Q&A from 7/11/2020 IBNA, 9/3/2020 CAC, and 9/11/2020 Shipyard HOA meetings

7/11/2020 IBNA Zoom Call

9/3/2020 CAC PD&F/Housing Subcommittee WebEx meeting

9/11/2020 Shipyard HOA meeting

Figure 1: Planned Bike Path Route Through Northside Park

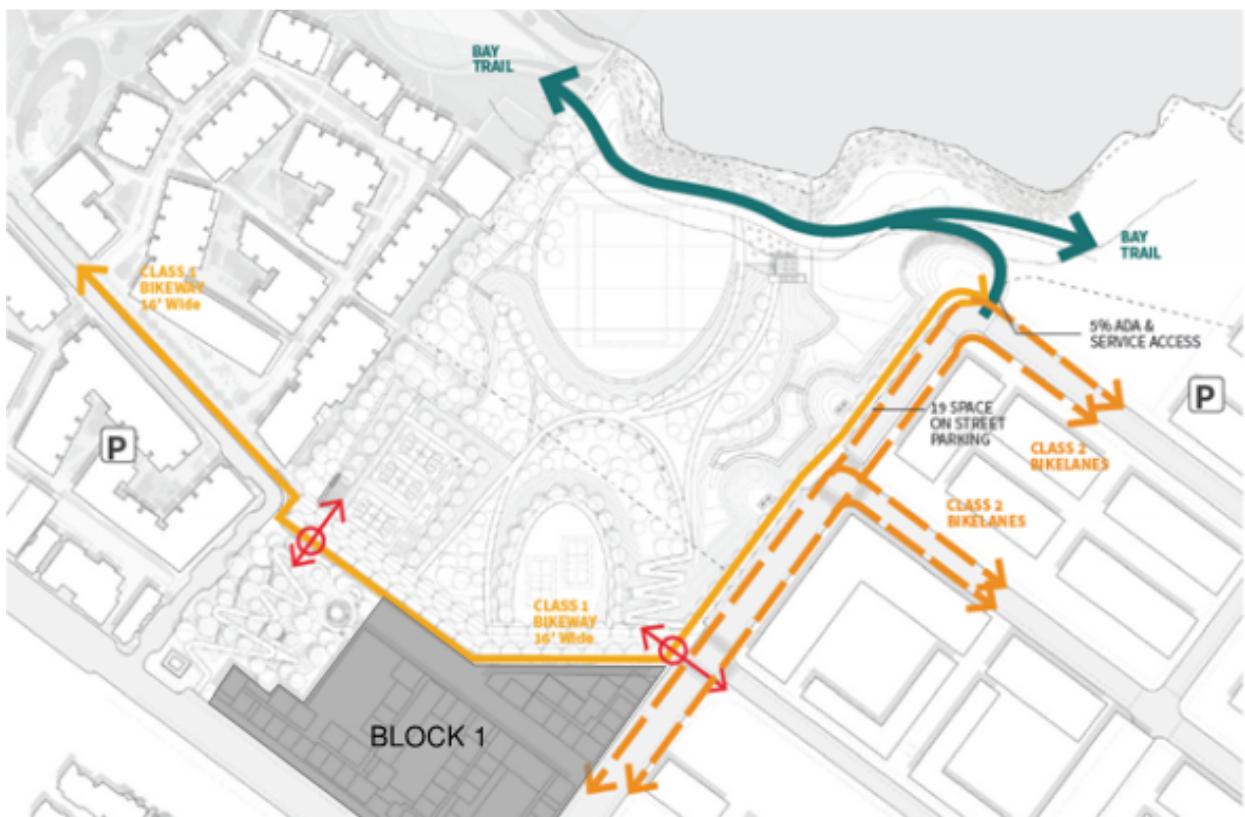
1Q. For safety and to encourage bike commuting, a Class 1 Bike Path running parallel to Innes Avenue has been part of our Community Vision for 10 years. The Recreation and Parks Department and Build, Inc are creating it on their properties. The Class 1 Bike Path will basically use the Hudson right-of-way from Hunters Point Boulevard to Earl. Will you continue the Class 1 Bike Path through your property (from Earl to Donahue)?

14Q. Please explain the zigzag path at Northside park.

1A. Per the Northside Park design provided to the developer by OCII, the Class 1 bike pathway connecting Earl to Donahue is located within Northside Park just North of the Block 1 development and is therefore the obligation of the horizontal developer for Phase 2 Hunters Point Shipyard (FivePoint). Per OCII, this will allow the bike lane to be better integrated with Northside Park when it is constructed.

14A. The overview for Northside Park is shown in Figure 1 above. Additional questions regarding the Park can be directed to Lila Hussain at OCII lila.hussain@sfgov.org. The winding path connecting from Innes Avenue to the future Market Street promenade within Northside park is a pedestrian access-way through the park. Because of the relatively steep topography at this location, for both ADA access and pedestrian comfort, the path has switchbacks.

Figure 4: Built Condition Rendering – aerial looking South

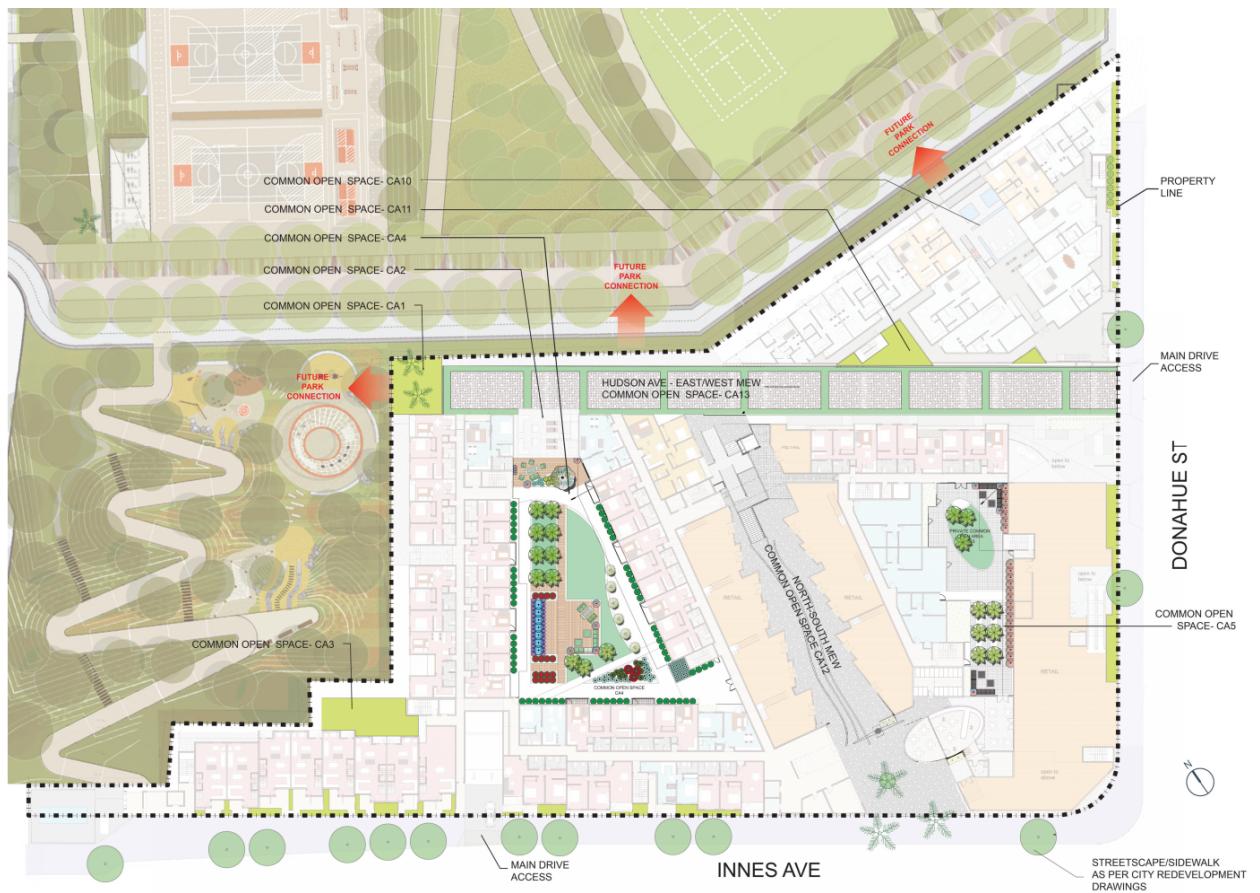
3Q. Can you indicate on your plans the connections from the Build, Inc project, Northside Park, the Bay Trail, and the existing Shipyard buildings that surround your property?

3A. Northside Park physically separates Block 1 from the Build SF development, thus there are no connections between Block 1 and the Build SF project (see Figure 2 below). The East-West Mews (Hudson St) provide two public connections from Donahue St through our project to Northside Park, and the North-West Mews provide a connection from Innes Ave to the East-West Mews. Those onsite mews are depicted on the project plans shown in Figure 3 below, and a design rendering showing the project integration with the future park is in Figure 4 below. The Northside Park interface with Block 1 is being further developed in coordination with OCII and the horizontal developer.

Figure 9: Green Rooftop locations

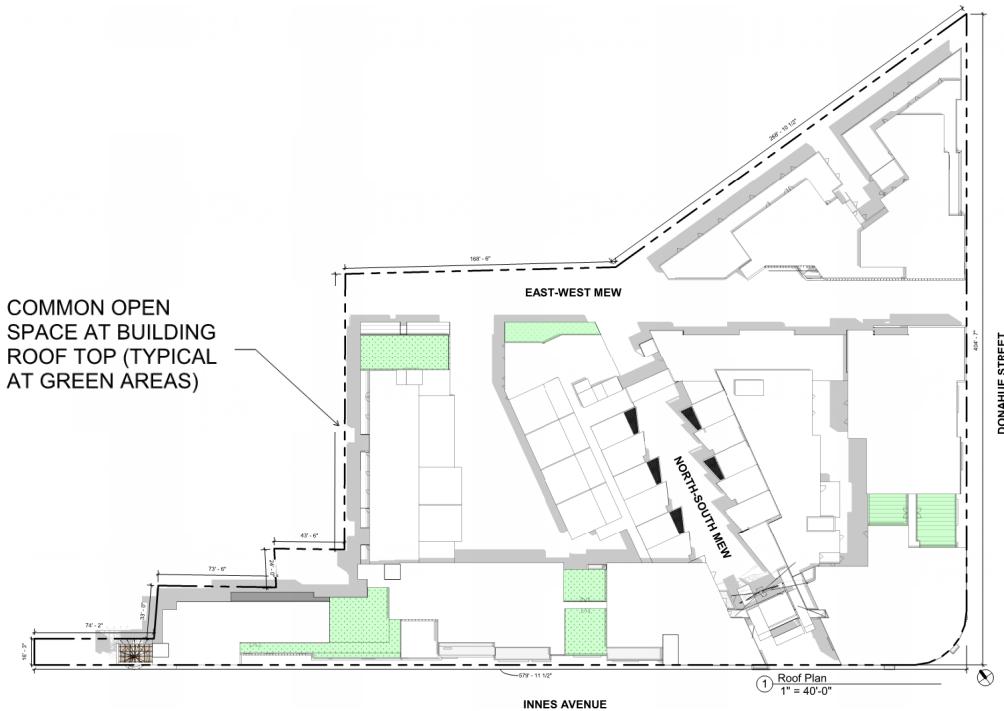
8Q. Will any of the rooftops be green roofs? Will any of the development have solar panels on the roofs?

8A. Some portions of the roof tops are green roofs (see Figure 9 below). The solar panels are setback from the street edges far enough to avoid a visual interference with the surrounding context.
